# 80960Jx Processor

Specification Update

*February 1999*

Order Number: 272852-007

**Figure 7. 196-Ball Mini Plastic Ball Grid Array Bottom View - Balls Facing Up**

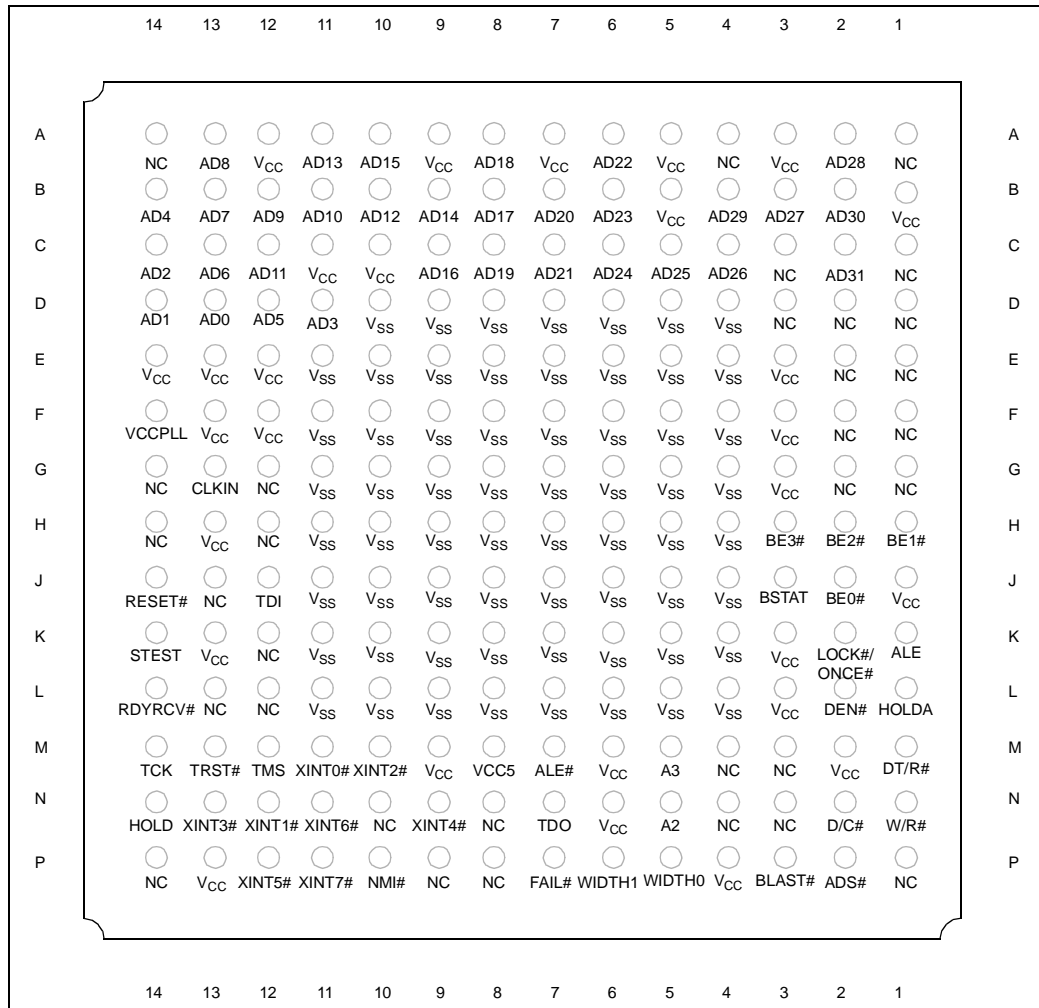
Figure 7 is the bottom view, “Balls Facing Up,” and should be oriented as shown:

#### Output Delay or Hold vs. Load Capacitance (3.3 V Signals)

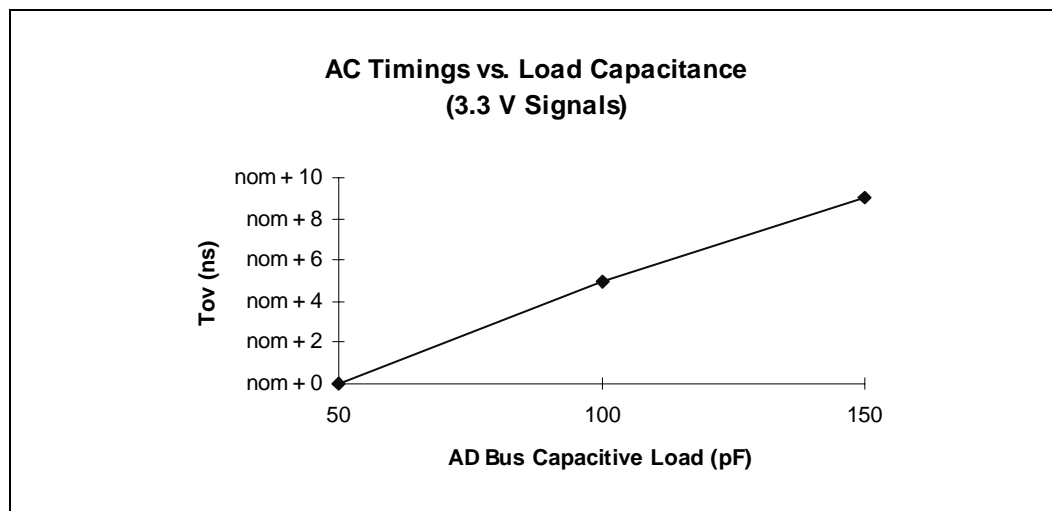
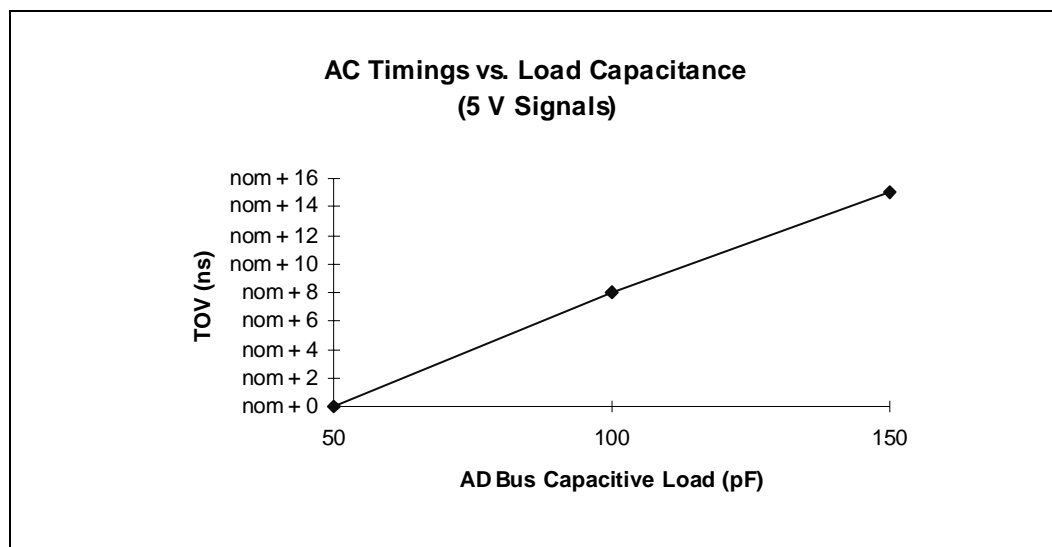
**Problem:** *80960JA/JF/JD/JT 3.3 V Microprocessor* datasheet, the “Output Delay vs. Load Capacitance” diagram and the “TLX vs. AD Bus Load Capacitance” diagrams do not apply to the 80960JT microprocessor (they are correct, however, for the JA/JF/JD microprocessors). The following diagrams and related notes provide the correct derating curve information for the 80960JT microprocessor:

**T<sub>LX</sub> vs. AD Bus Load Capacitance (3.3 V Signals)**

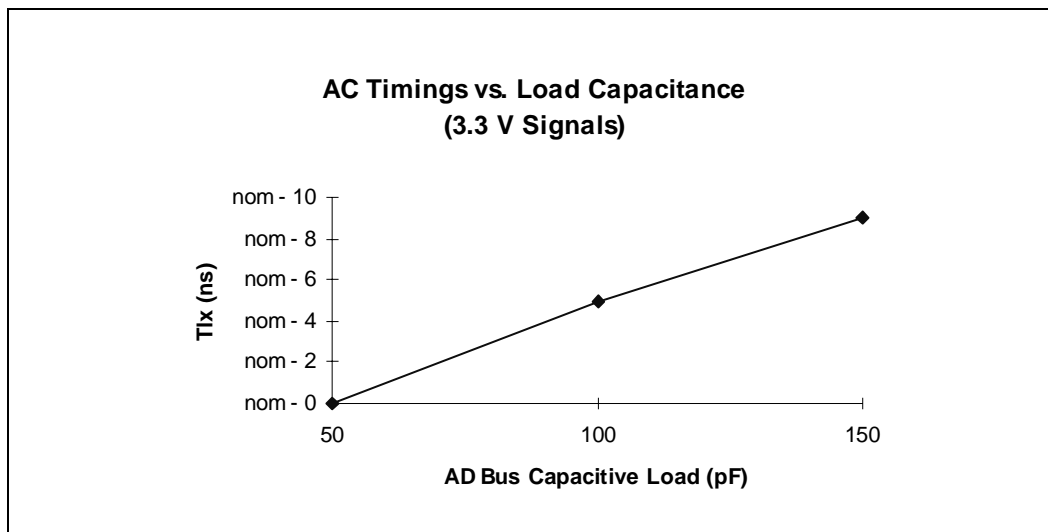
**Note:** The T<sub>LX</sub> Derating curve applies only when an imbalance in the capacitive load occurs between the AD bus and ALE. The T<sub>LX</sub> derating is based on a 50 pF load on ALE. The derating applies to ALE and ALE#.

**T<sub>LX</sub> vs. AD Bus Load Capacitance (5 V Signals)**

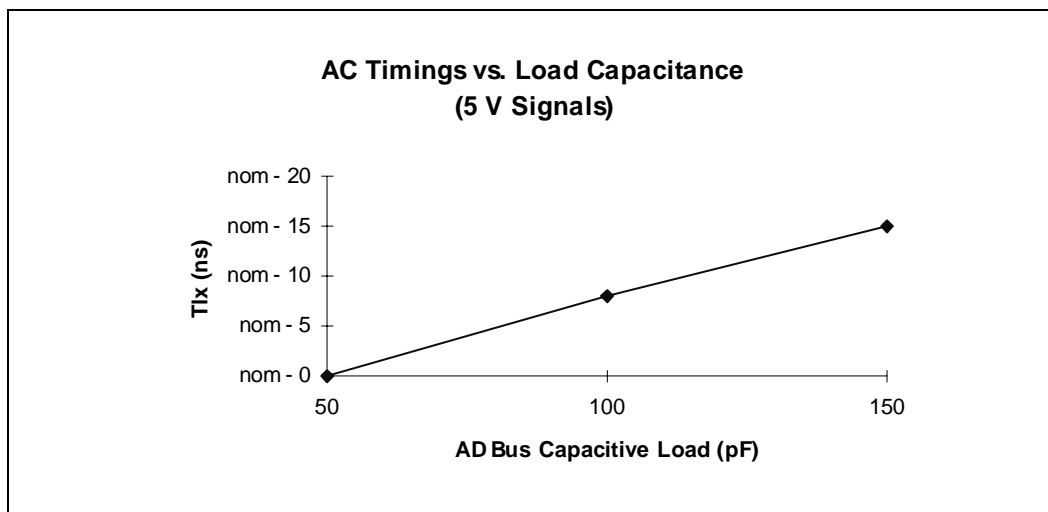
**Note:** The T<sub>LX</sub> Derating curve applies only when an imbalance in the capacitive load occurs between the AD bus and ALE. The T<sub>LX</sub> derating is based on a 50 pF load on ALE. The derating applies to ALE and ALE#.
